CIVIL ENGINEERING ASSOCIATES, INC.

**Re: Development Application – Turf Care Center Redevelopment
Stowe Country Club, LLC
Project 7200 – 744 Cape Cod Road at 400 Cape Cod Road**

In accordance with guidance provided by the Development Review Board at the October 3, 2023 Site Plan and Conditions Use hearing, the applicant had revised and supplemented the application materials.

**DEMOLITION
PLAN**

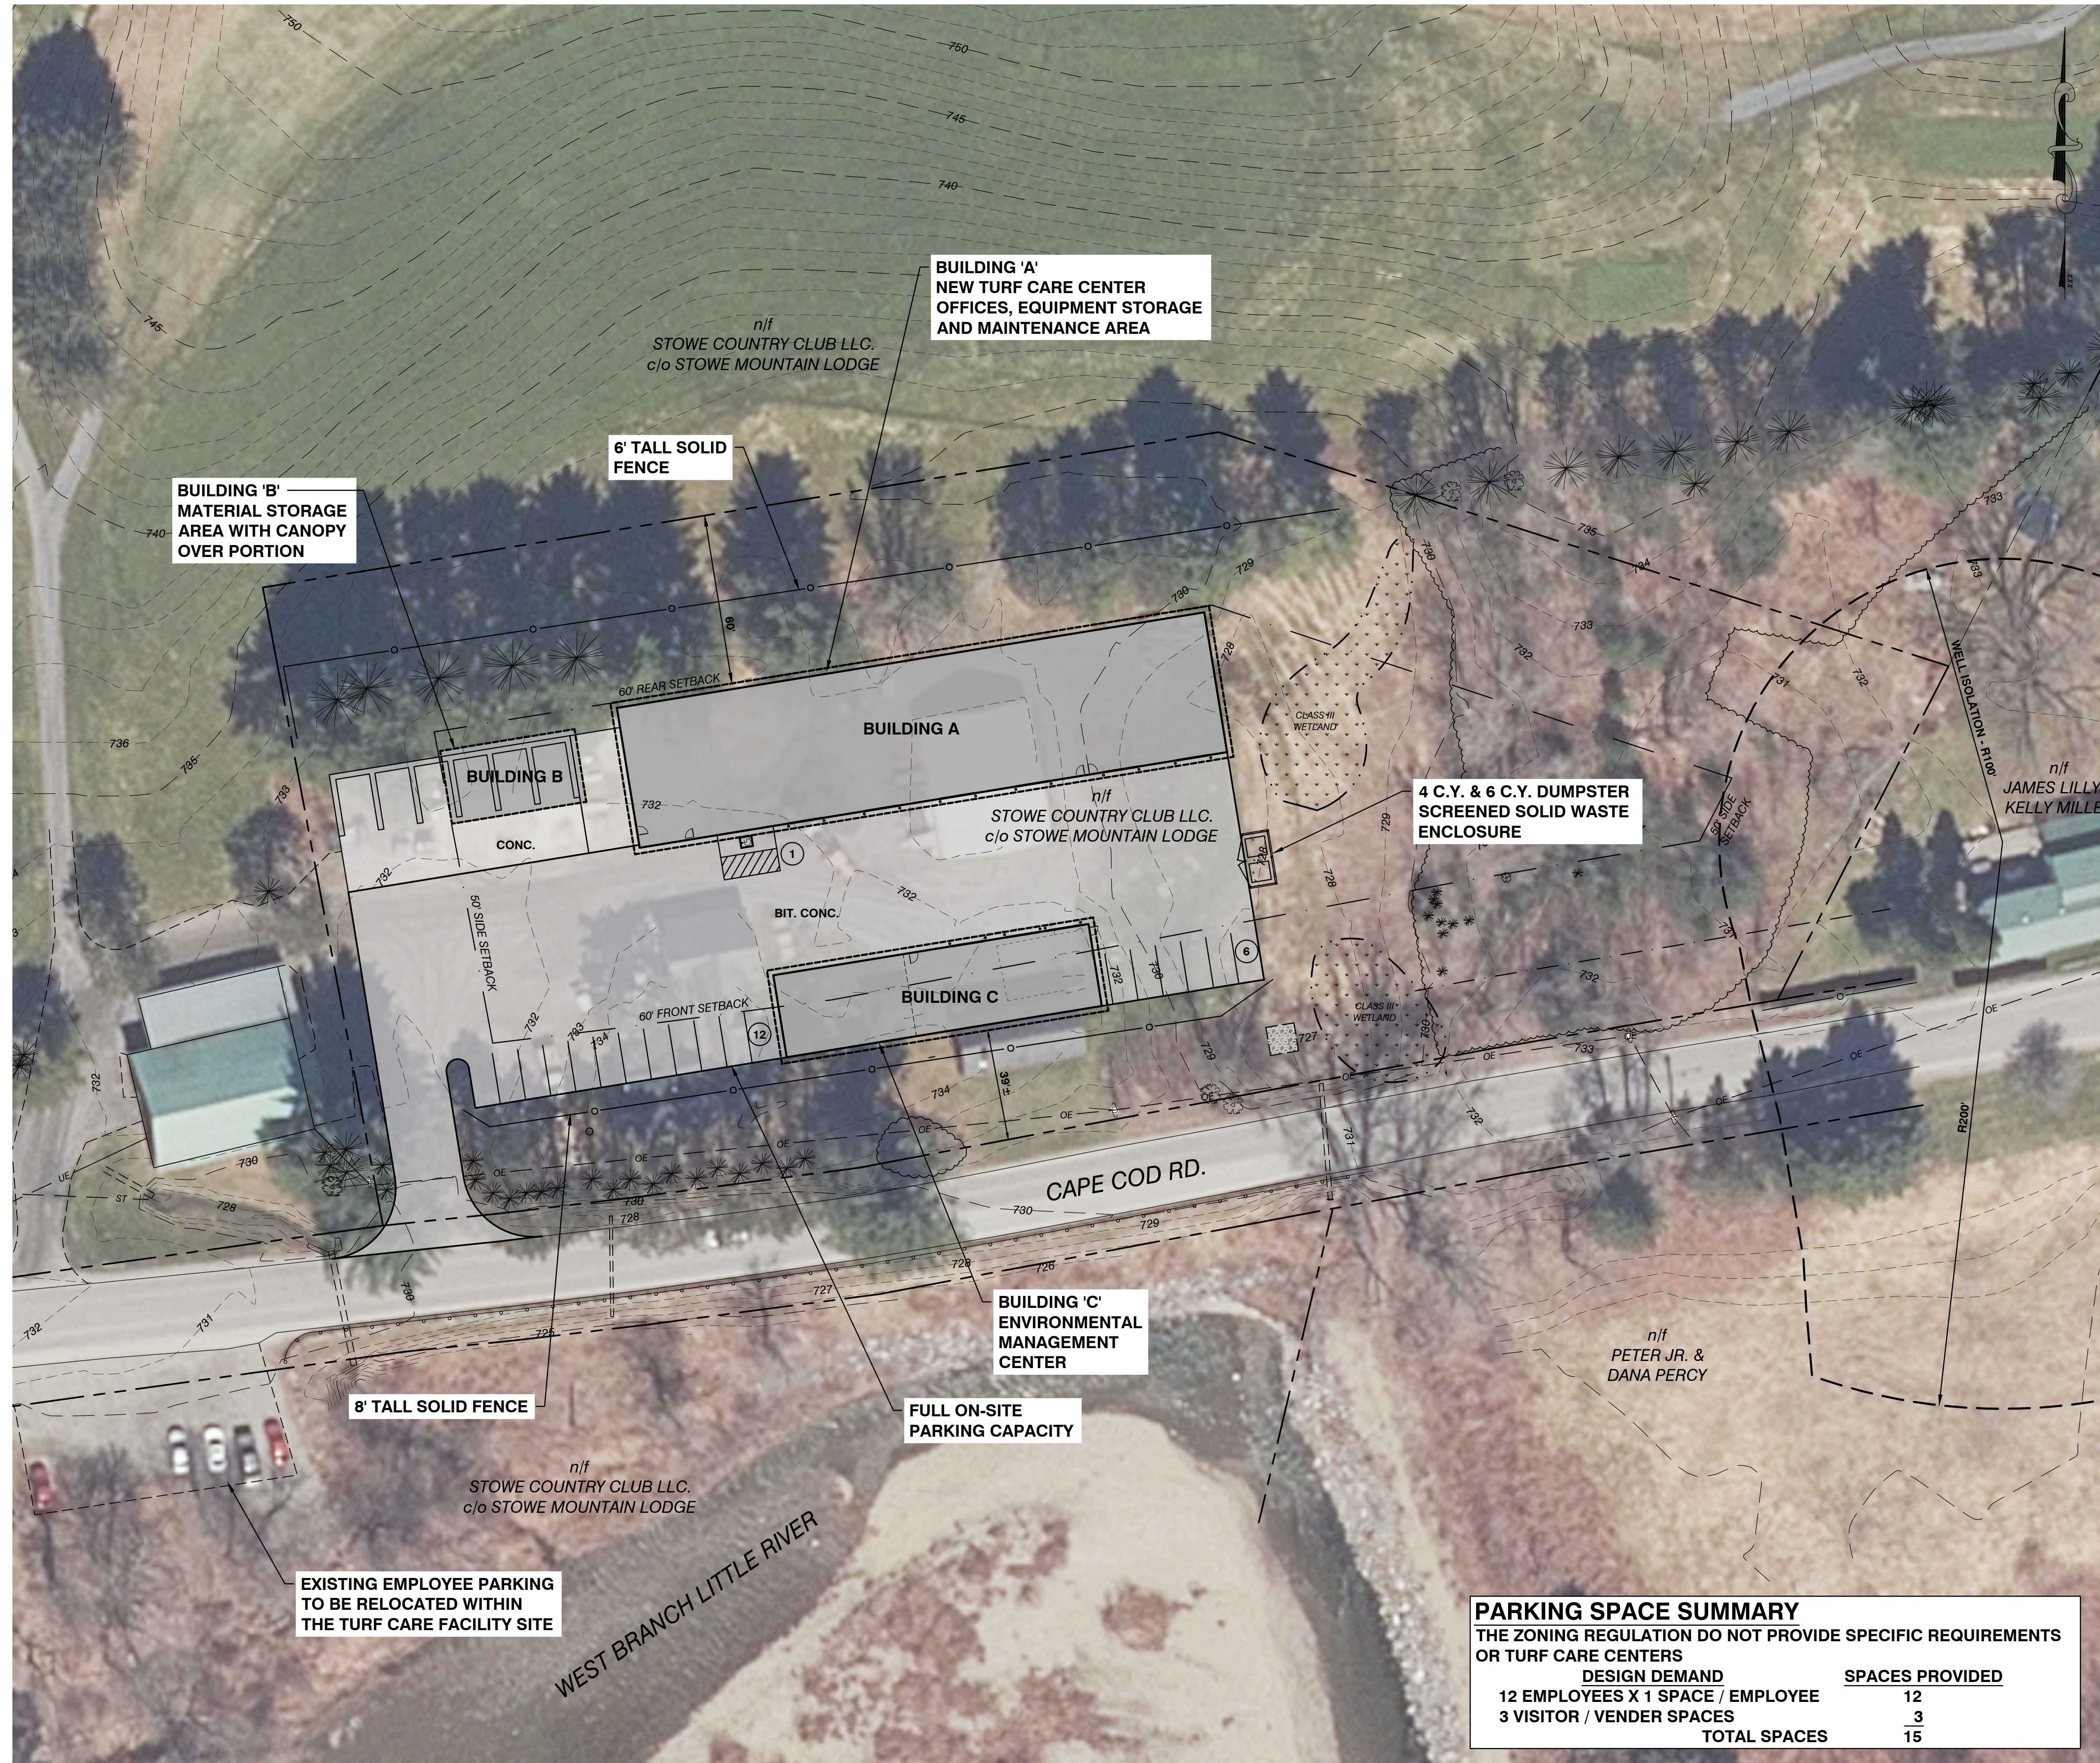
C1.20 – Demolition Plan – This is a new sheet to provide a concise representation of the demolition components.

**PROPOSED
CONDITIONS
PLAN**

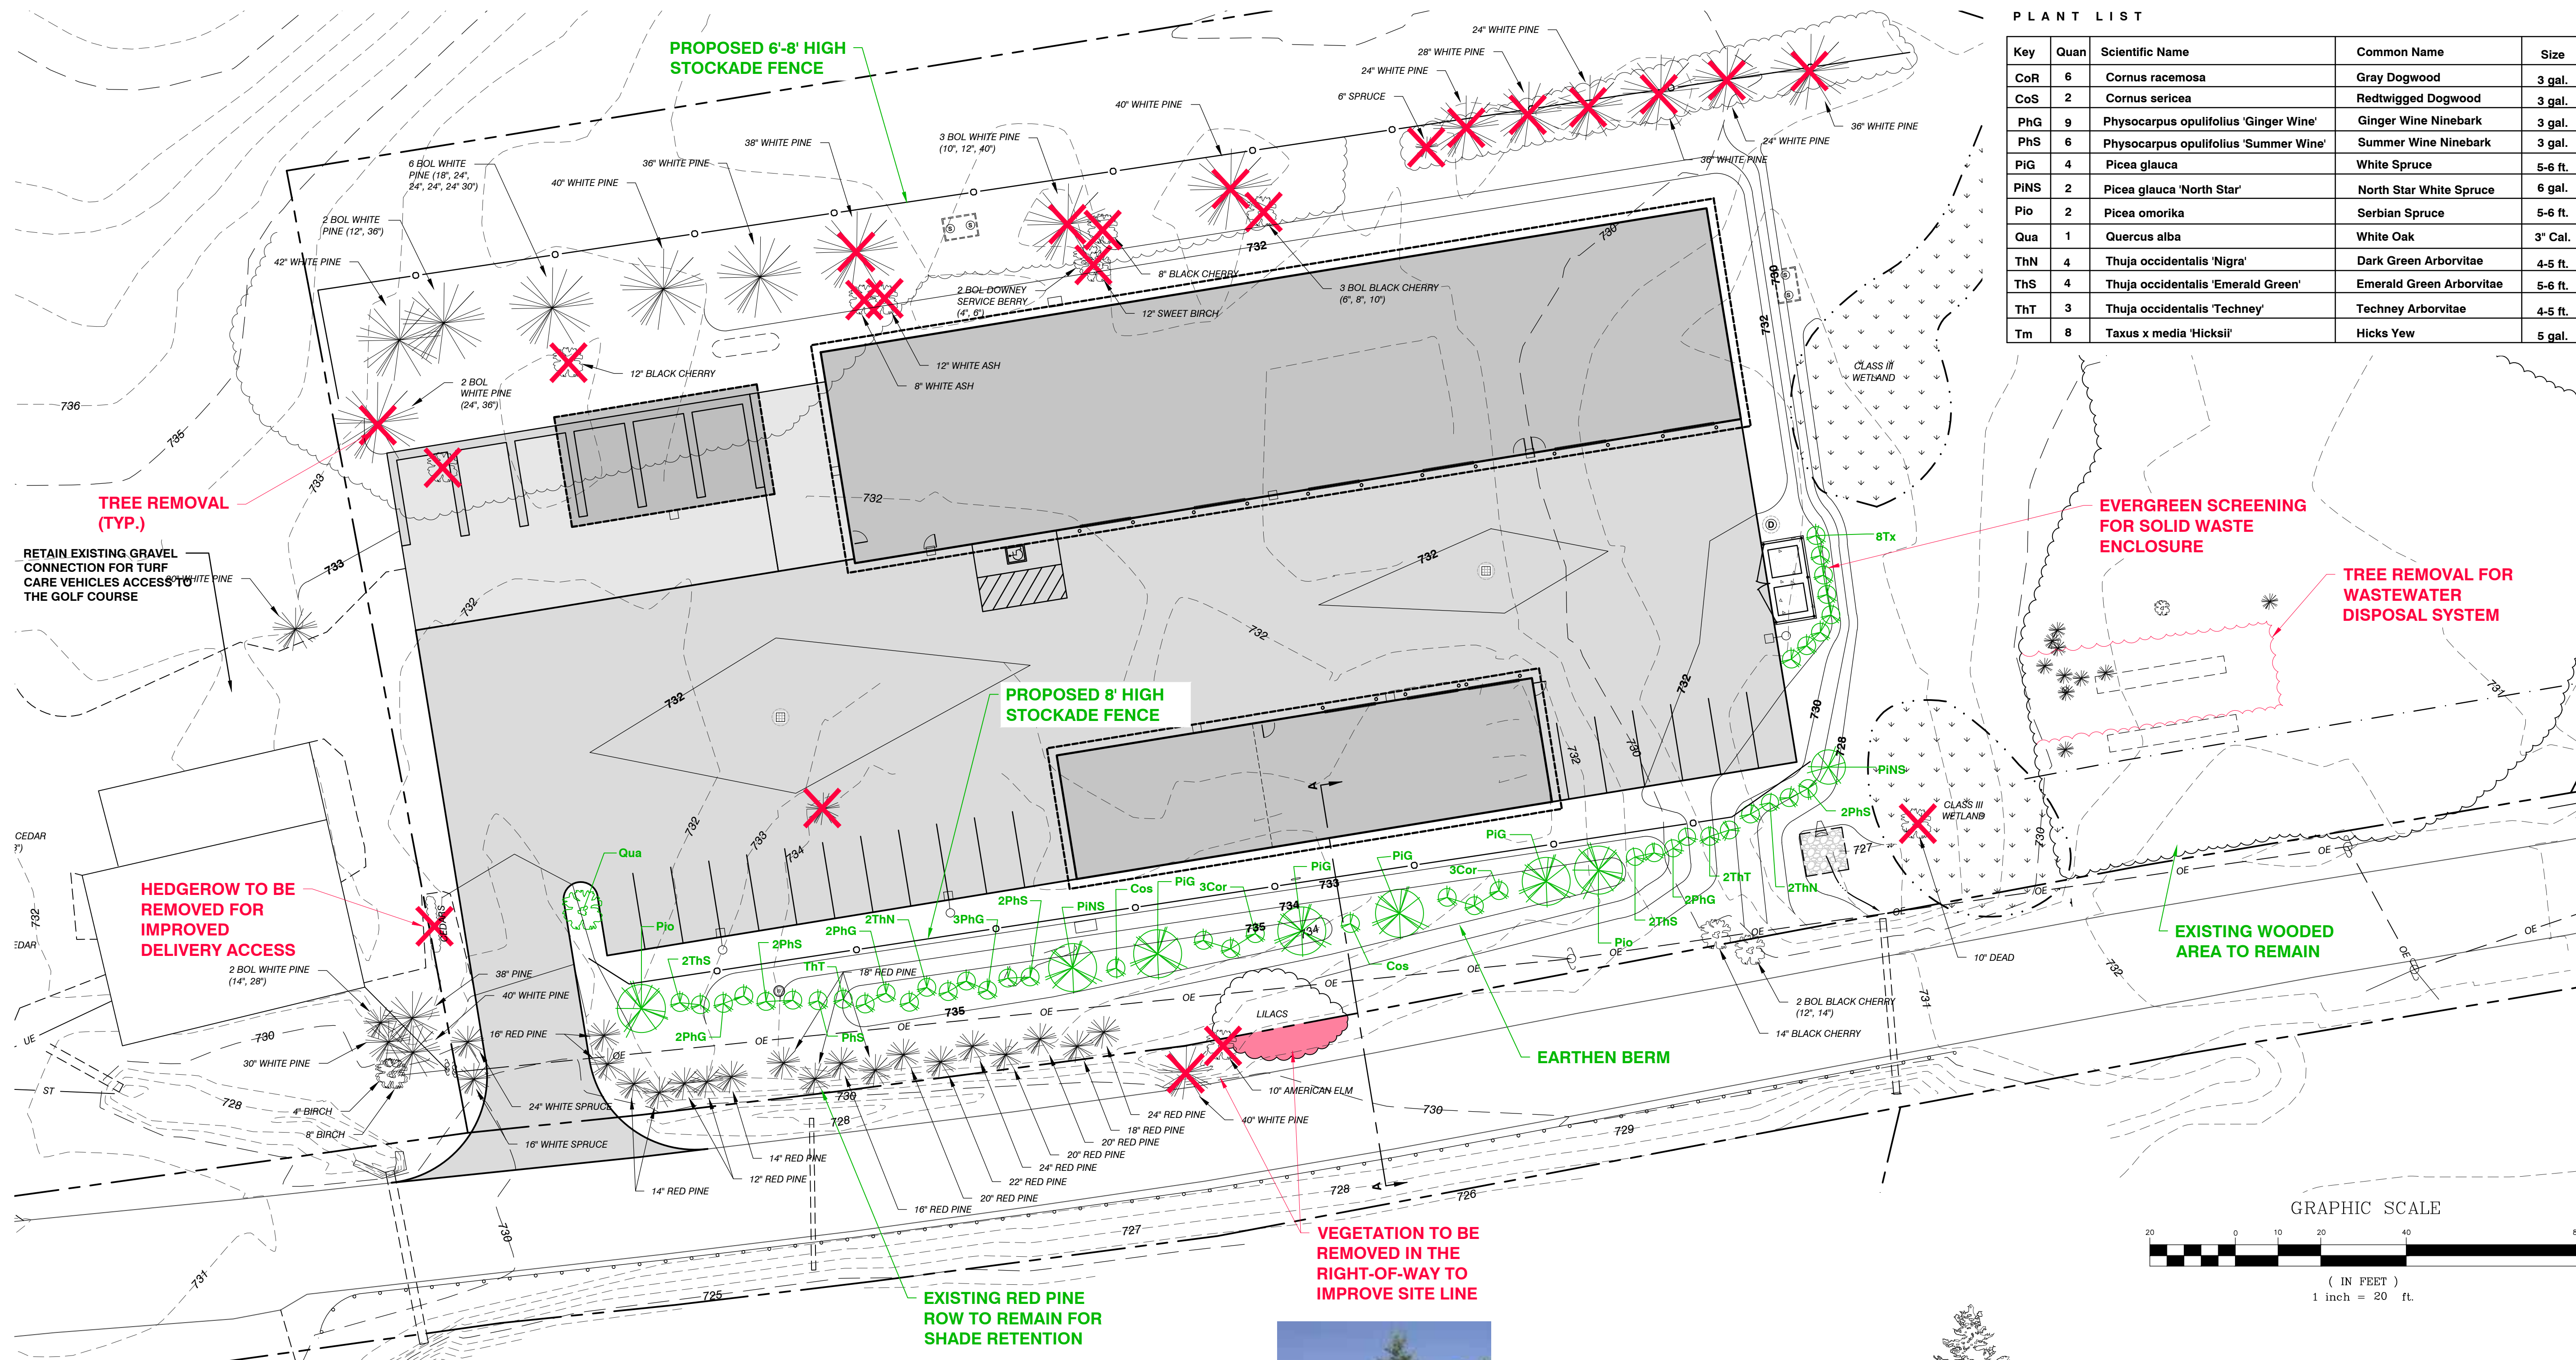
C2.00 – Proposed Conditions Plan

- Removed references to work on the adjacent property to the west .
- Removed the old property line and depicted the current property lines
- Added the roof overhang on the buildings and moved Building A to comply with the 60' rear yard setback requirement.
- Added a Proposed parking summary table at the bottom right of the plan.
- Added a stockade fence along the south side of Building C.
- The front yard setback from Building C was revised to 39 feet to reflect the inclusion of the eave on the south side of the building.

LANDSCAPE PLAN

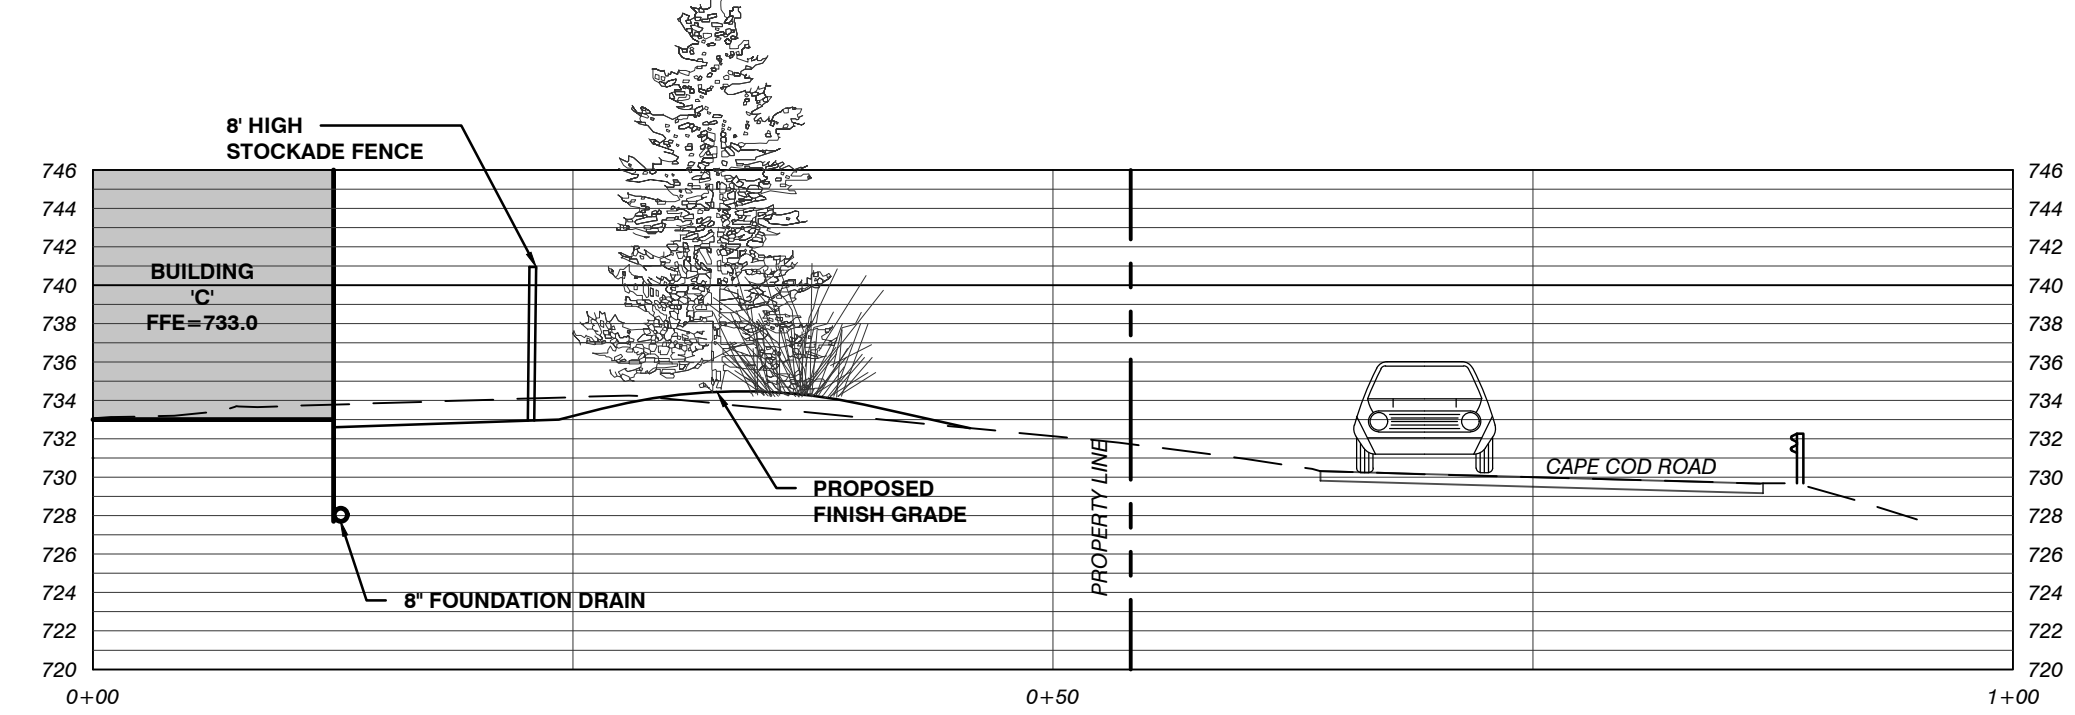
L1.00 – Landscaping Plan

- Removed old property line
- Added stockade fence along the south side of Building C.
- Consolidated notes from Sheet L1.01 on this sheet and eliminated L1.01.
- Added likeness image of stockade fence.

SITE LIGHTING PLAN

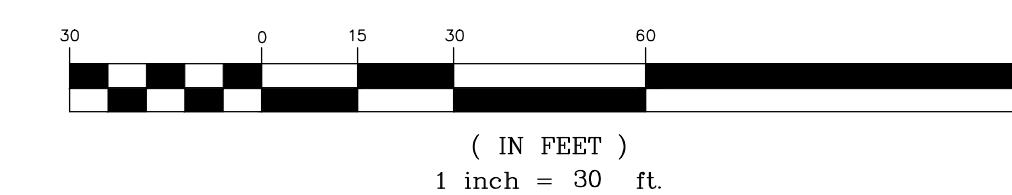
C2.40 – Site Lighting Plan

- Formalized the Lumen Count and Density calculations.
- Added narrative regarding operation of the lights after hours.

The area lights will be set on a timer in which the lights will be turned off one-hour after astronomical sunset. Lights will be enabled to be turned on no sooner than one-hour before astronomical sunrise.

BUILDING "C" ENVIRONMENTAL
MANAGEMENT CENTER
FLOOR PLAN & ELEVATIONS

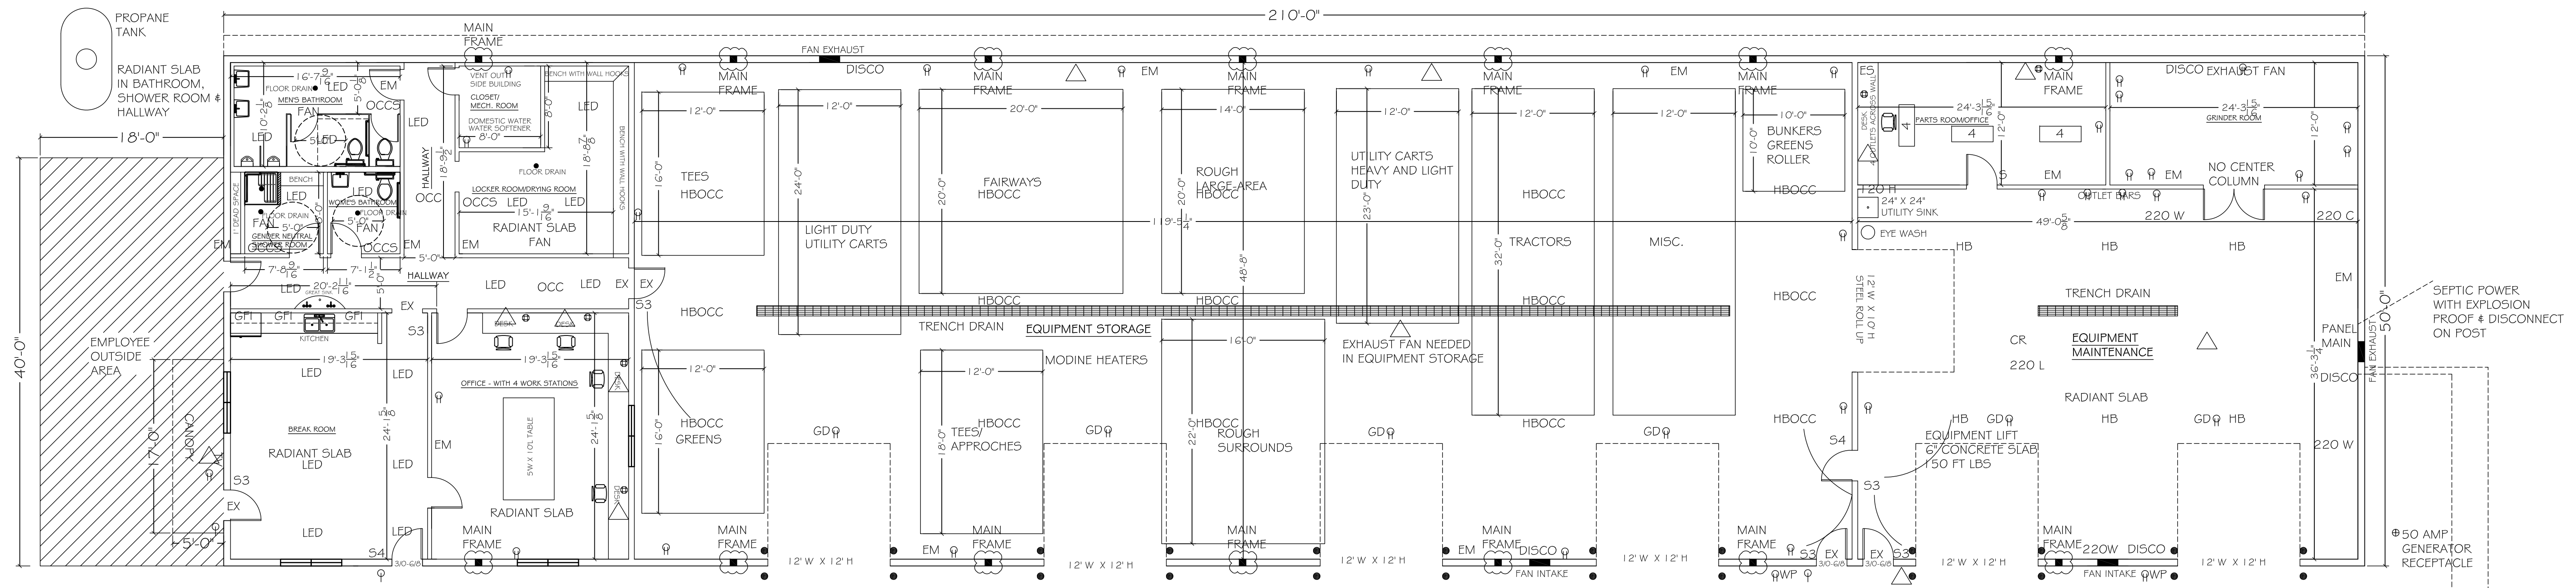
- Added code compliance references and building features tables.
- Added dummy windows on south elevation
- Added Board & Batten siding on south, east and west sides
- Updated overhead doors
- Added hatching to the solid wall portions of the building.
- Removed CarbTrol treatment system for clarity
